Reserved Matters Application – Havant Thicket Reservoir Phase 2 – Wetland

HBC reference: APP/24/00186

EHDC reference: 51680/008

Concerns / comments/ queries on Phase 2 Wetland application

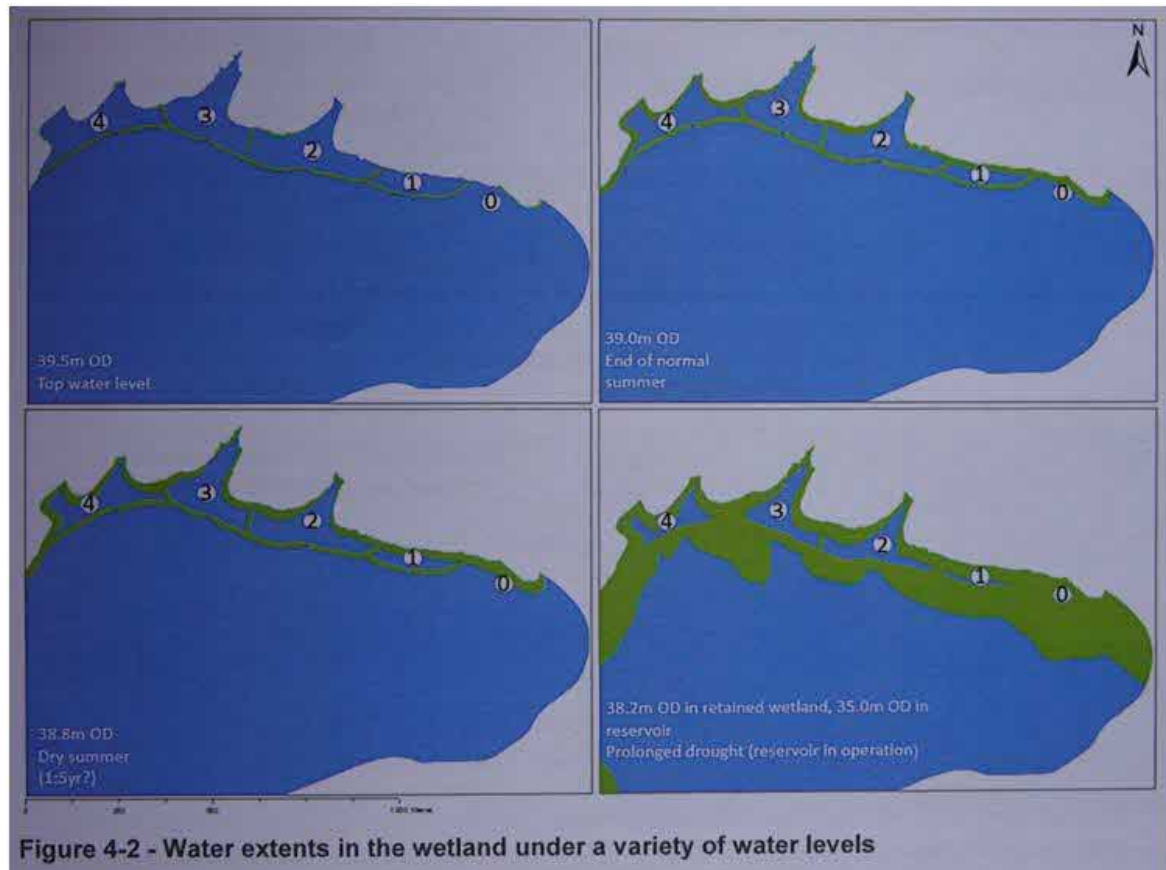
When the original reservoir outline hybrid planning application was submitted, we were told that the developer could not provide photomontages from key viewpoints as the detailed design of the wetland had not been completed, which would determine the final location of the wetland retaining structure and islands. This design work is now complete and particularly given the significant design change to introduce a high bank along the northern shore it would be **reasonable to expect the applicant to provide the LPA with a landscape impact assessment including photomontages from key view points**. This should include; from the view points on the reservoir embankment at the end of the Avenue and at Gammon Hill, from the NW shore (visitor centre area), from the interpretation hide on the NW shore of compartment 4, from the culvert view point where the compartment 4 stream entry crosses the category A FE track, from the proposed central hide (looking east and west) and from the eastern hide (looking west).

This should include a comparison of what the views would have looked like before the introduction of the proposed new high bank along the northern shore.

When assessing the detailed design of the wetland it is important to understand that the spillway level of 38.8m is not the lowest the water level within the retained wetland will reach. Now that the island locations and detail for the ephemeral shallows have been determined it would be extremely helpful to provide the equivalent maps for the new design to understand the impacts on views and upon the value of the wetland under different scenarios (i.e. how much water would remain and where mud will be exposed. This will help to identify further refinements needed to the wetland design to optimise its value under low water level scenarios.

Note: Stakeholders did ask that this information be submitted with the planning application. The statement made in the Planning Statement Section 2.4 that "water within the wetland area will be maintained at 38.8m AOD regardless of main reservoir levels, unless the wetland is drained for

maintenance or emergency reasons” is not true. As shown on the maps below evaporation during prolonged dry spells will reduce the water level below 38.8m.

I would ask that the LPA request the developer provide the following information for consideration before the application is determined;

- A landscape impact assessment for the detailed design including photomontages from key viewpoints, ideally illustrating the impact of different water levels.
- A series of maps showing the impact on the water level in the retained wetland under different operating regimes/ climate scenarios, to update the maps shown above.
